## **A57 LINK ROADS**

**TR010034**

**RESPONSES TO DEADLINE 4 SUBMISSION**

**CPRE PDSY REBUTTAL OF NH'S RESPONSE TO OUR WRITTEN REPRESENTATION - REP2-069, REP2-070 AND REP2-071**

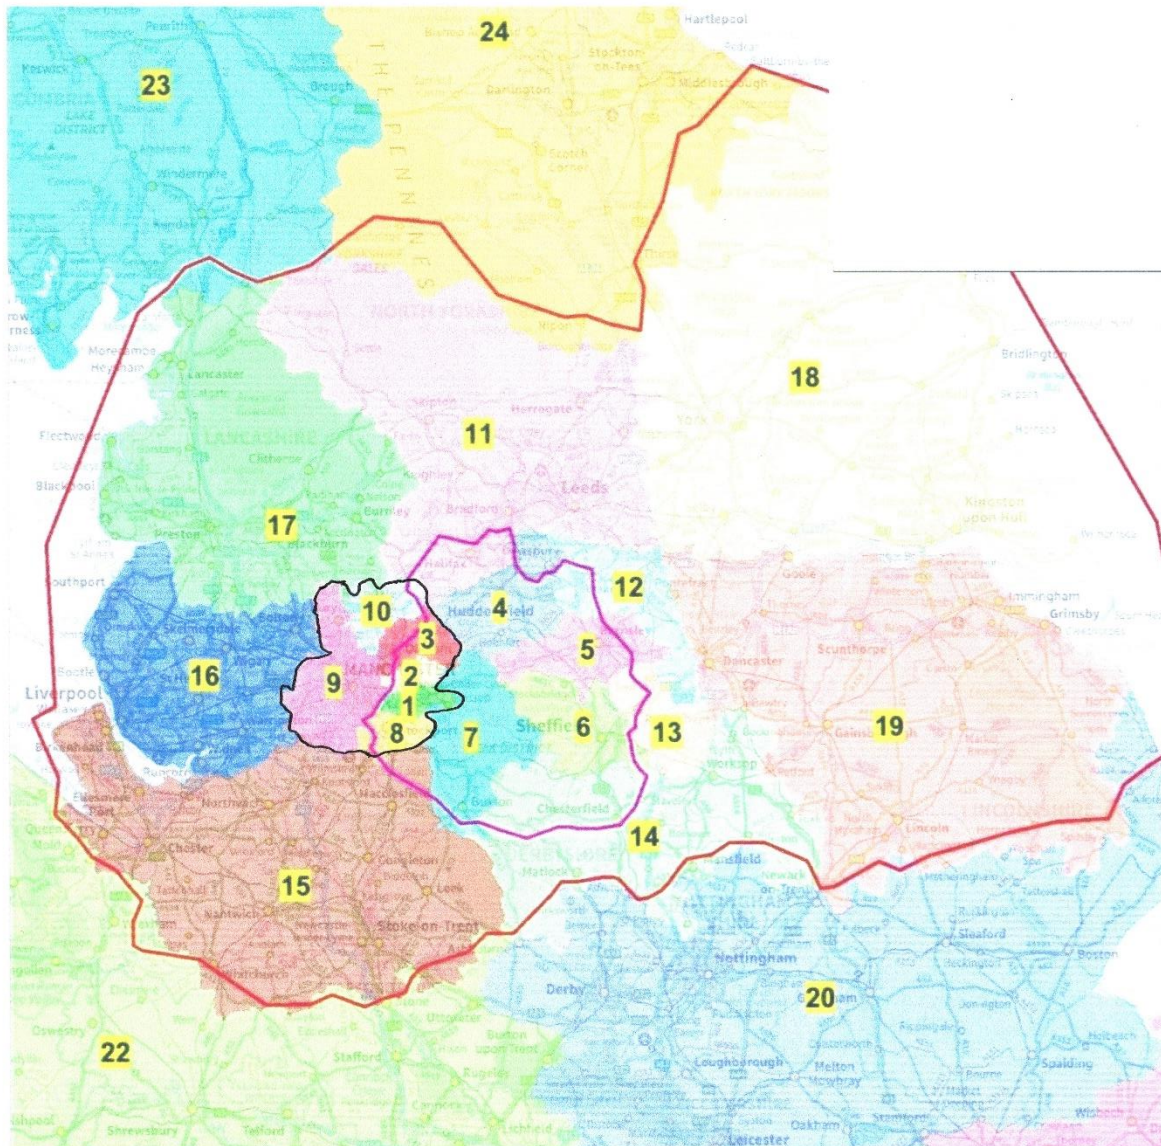
In the D4 submission the information from NH was used to show more precisely where the benefits from the proposed scheme were predicted to occur. The point was made that a majority were in areas where encouraging more driving was counter to national and local policies (basically towns and cities including Greater Manchester and Sheffield). To illustrate this further, we have now considered only those trips which are **entirely within** Greater Manchester. These still provide 55% of the total benefits from the proposed scheme's economic analysis. This is despite the limitations in these areas caused by the Fixed Cost Function and masking. The area we have selected is the closest possible using the 25 sector system and is shown below outlined in black. As well as supporting the point that this is essentially a scheme with urban impacts where they run counter to current policies, the figure below illustrates why more detailed modelling should have been done in that urban area.

*Please note: the area within the inner purple boundary is not the same as the ADM which is smaller. The ADM map could not be used because it is not large enough to show the zones. This is the map supplied by NH in the Combined Modelling and Economic report submitted in response to the CPRE request.*
